Changing the Momentary Only to Momentary/Latching

This document shows the modifications that are needed on the speaker stations and the wall mount user stations to change the Talk button from Momentary Only Operation to Momentary and Latching Operation.

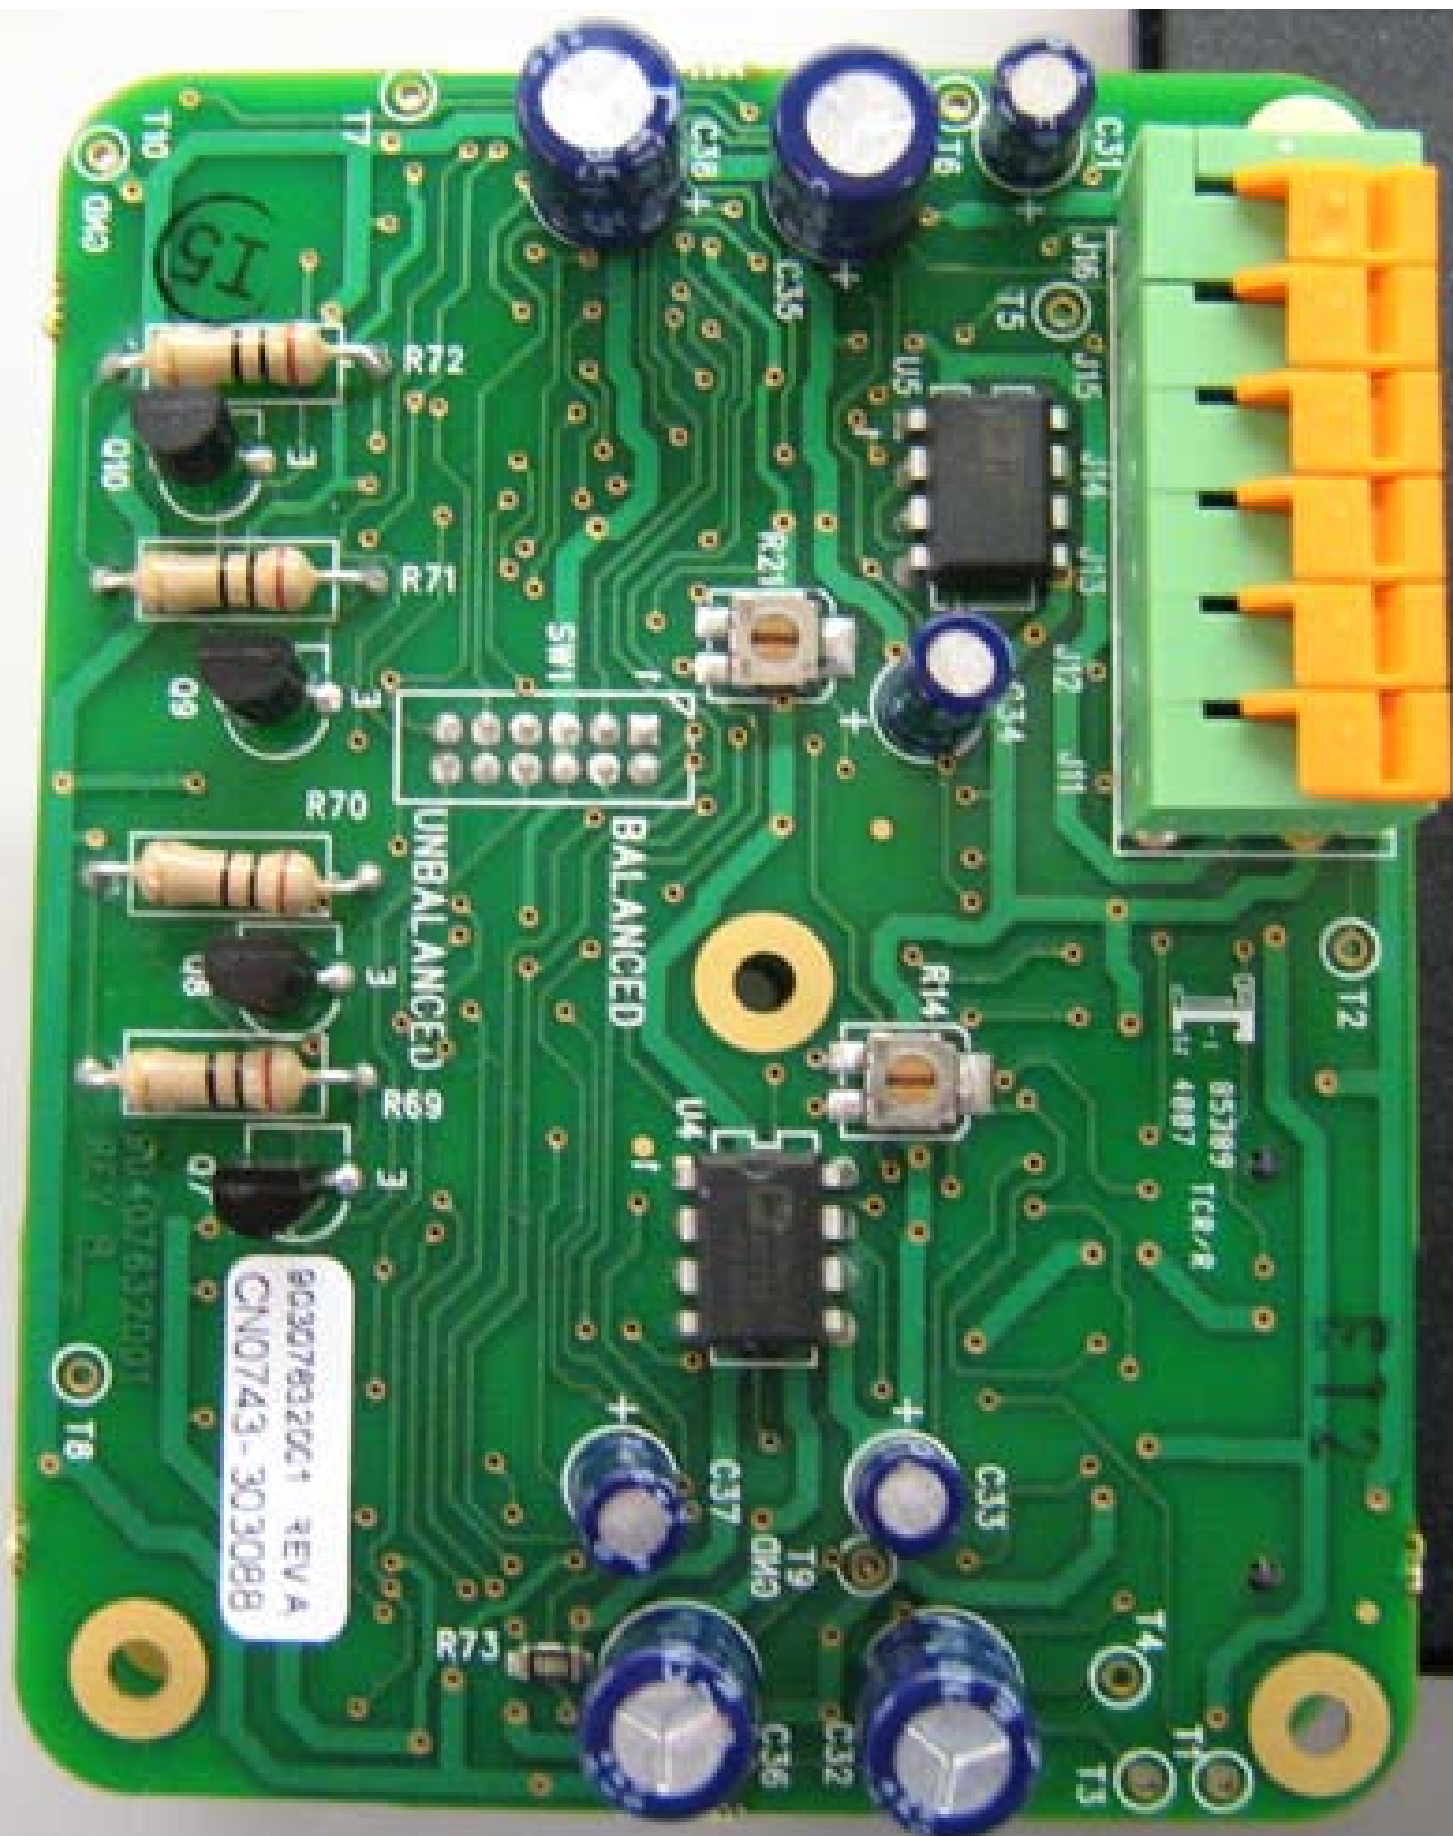
The third photo shows the middle board from the top side. Q5 must be removed in order to have the Talk Latching option. Q5 is circled on the photo. Q5 is located on the opposite side of the board from the red DIP switch.

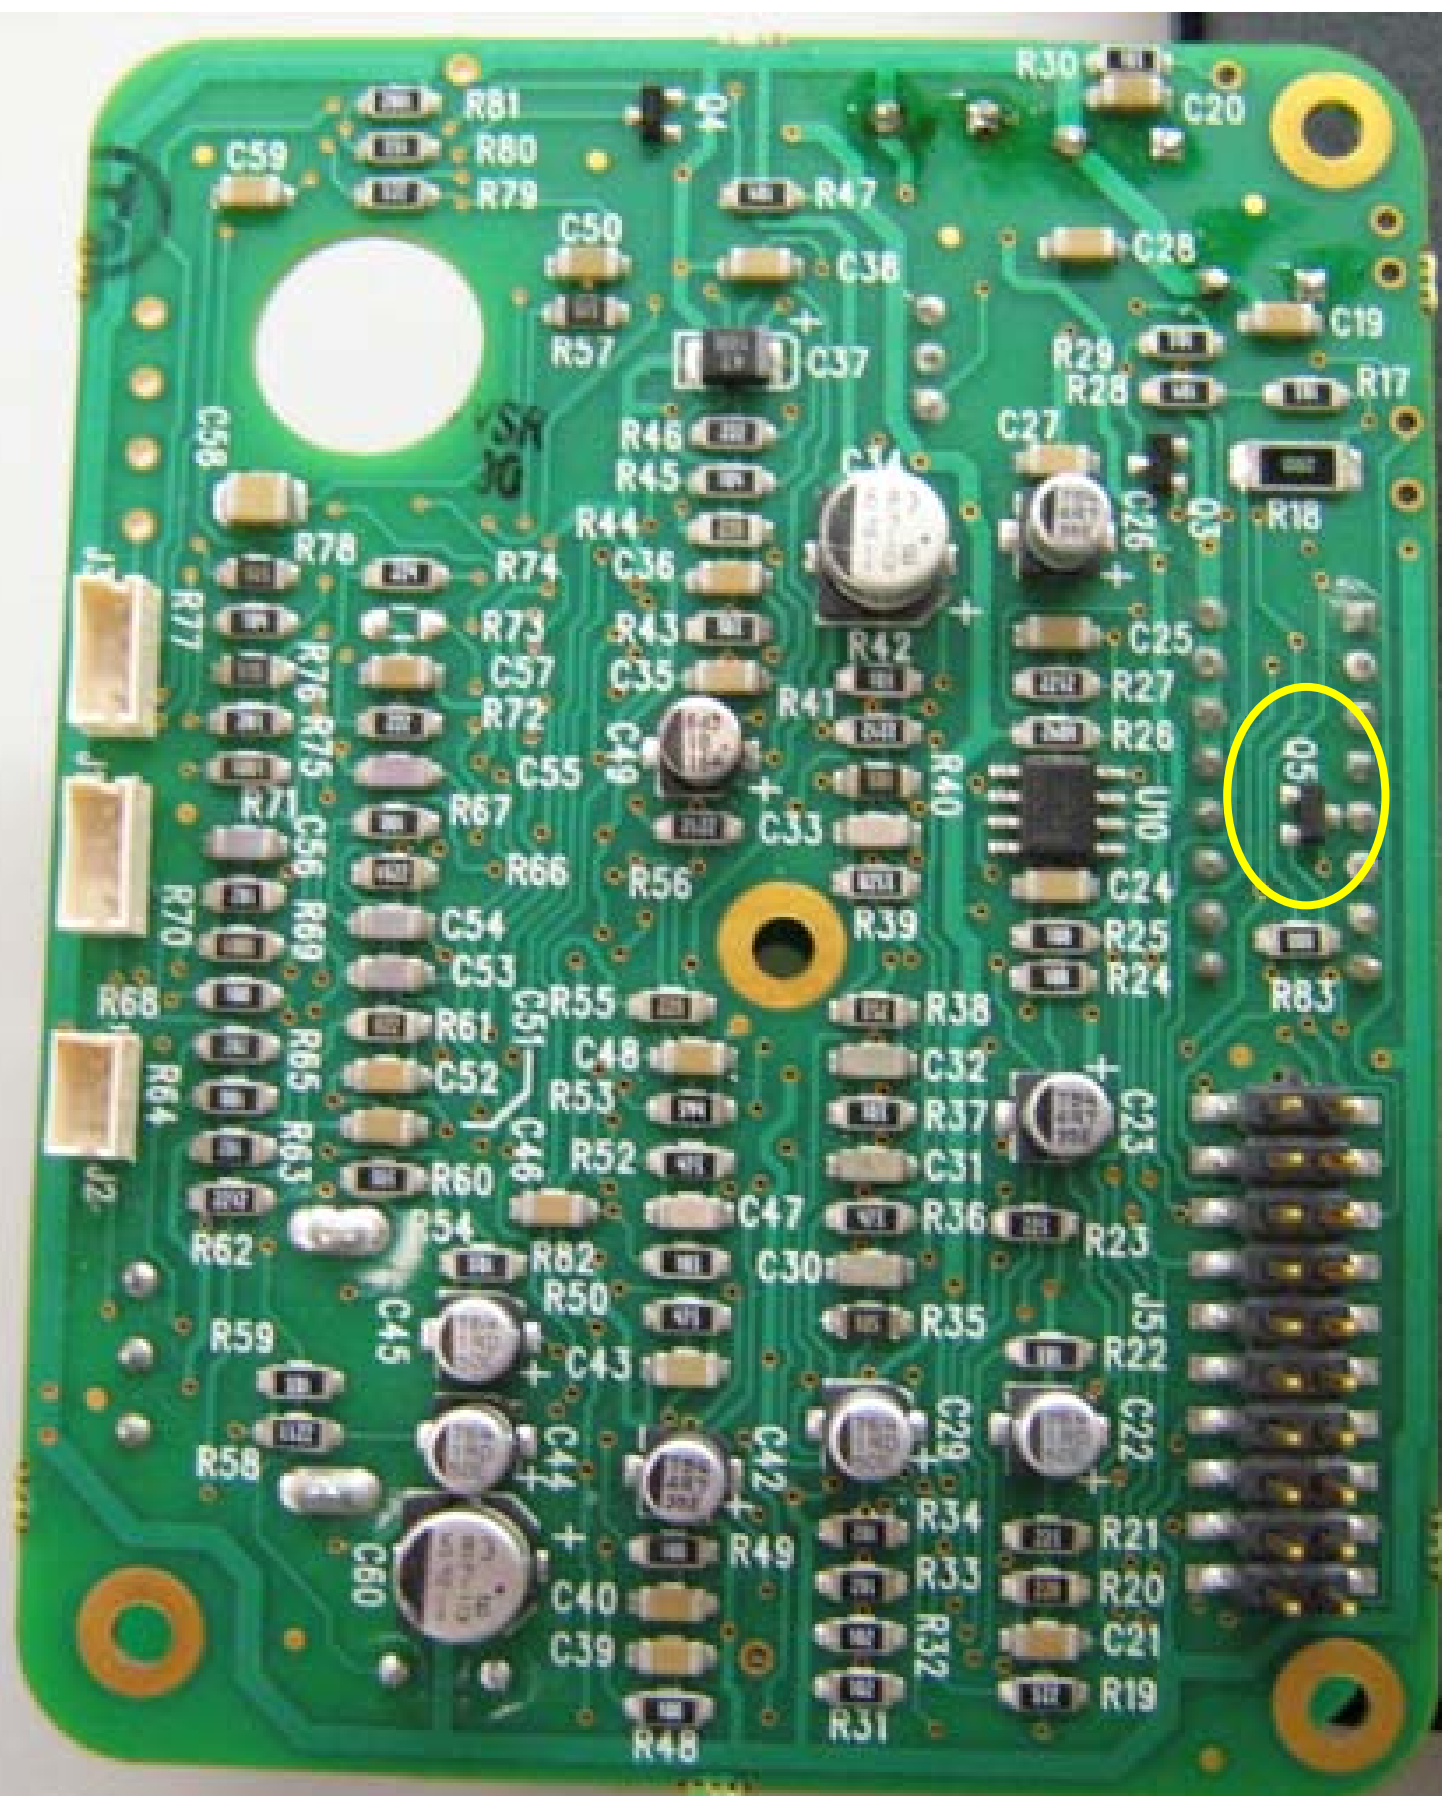
The fourth photo is a close up picture of Q5.

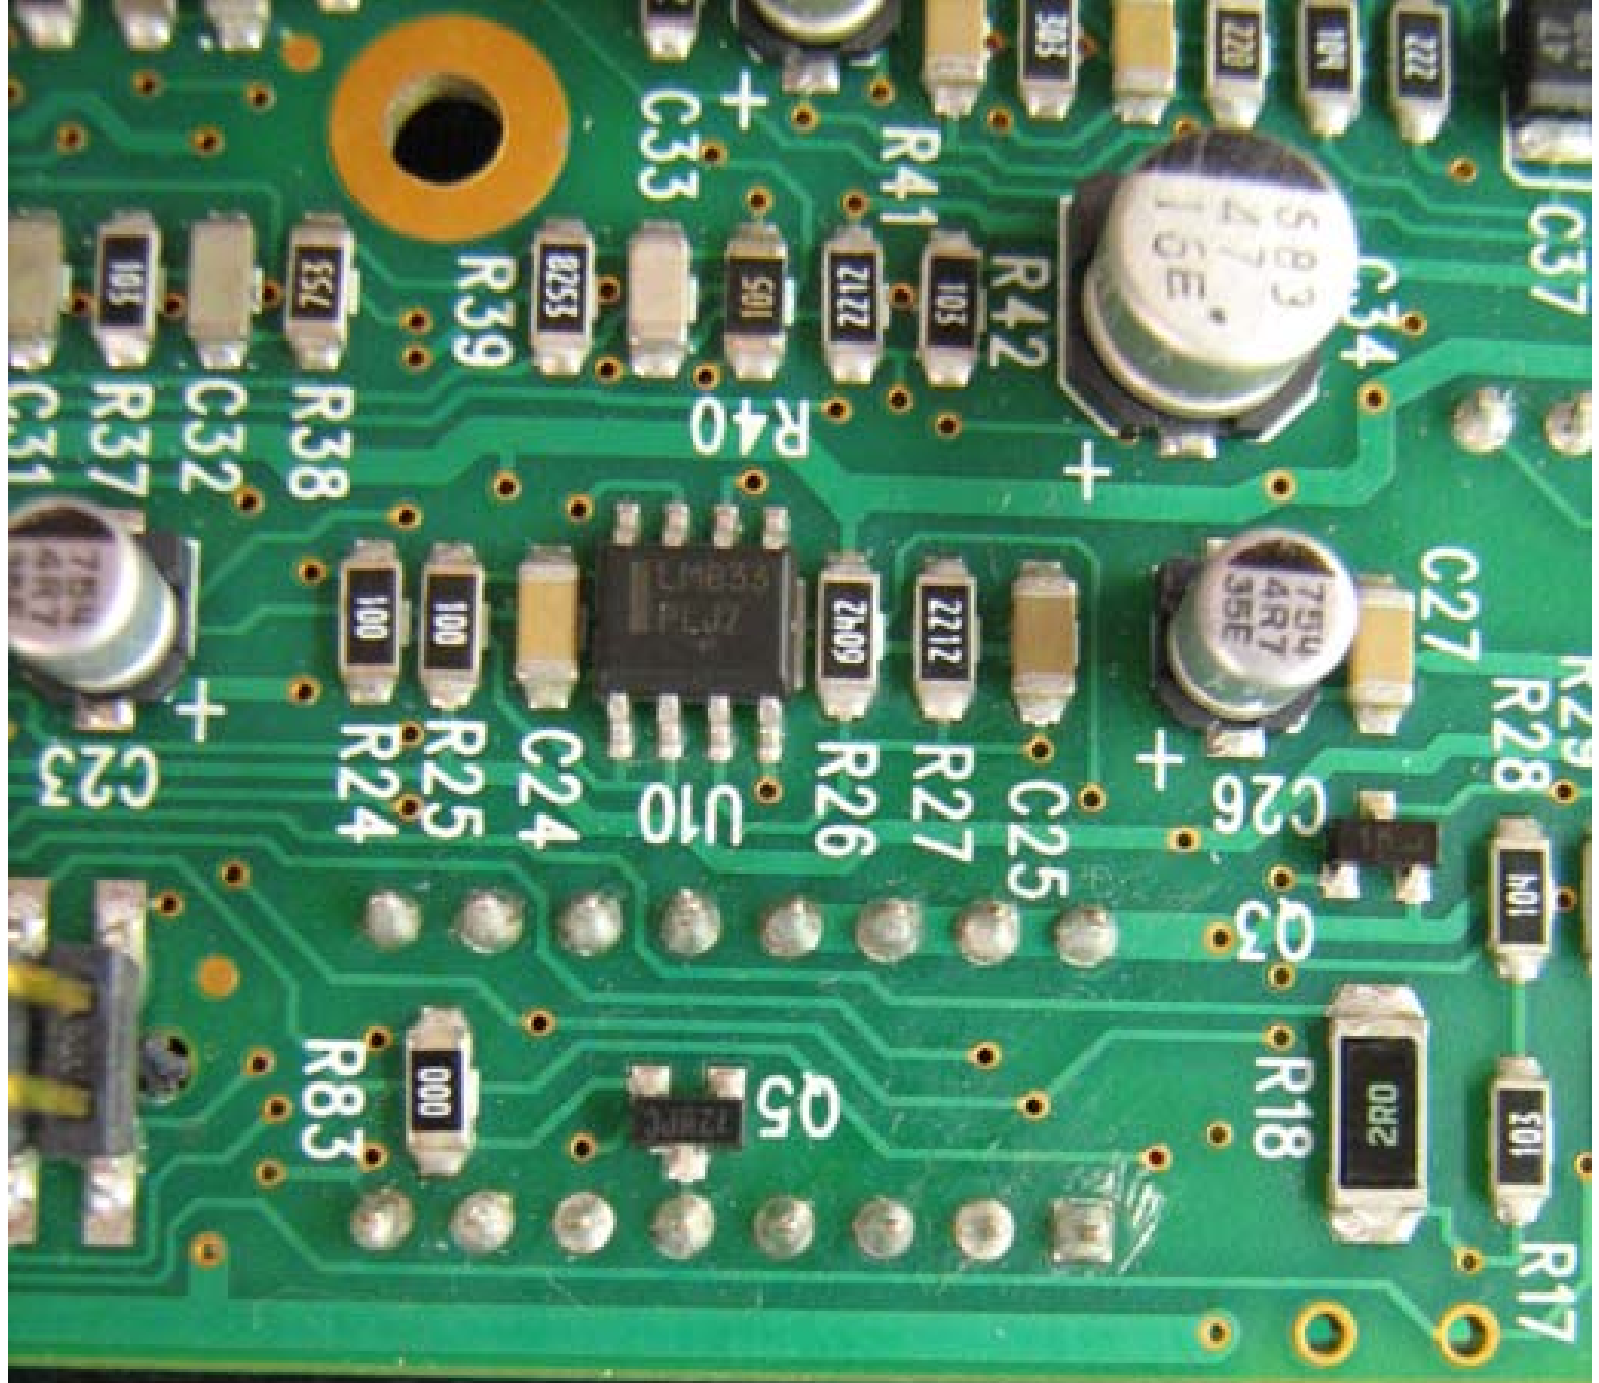
The fifth photo shows the bottom or keypad side of the keypad board. This is the side that is behind the silicon rubber keys. C1 must be removed in order to have the Talk Latching option. C1 is circled on the photo. C1 is located on the opposite side of the board from the socketed microprocessor.
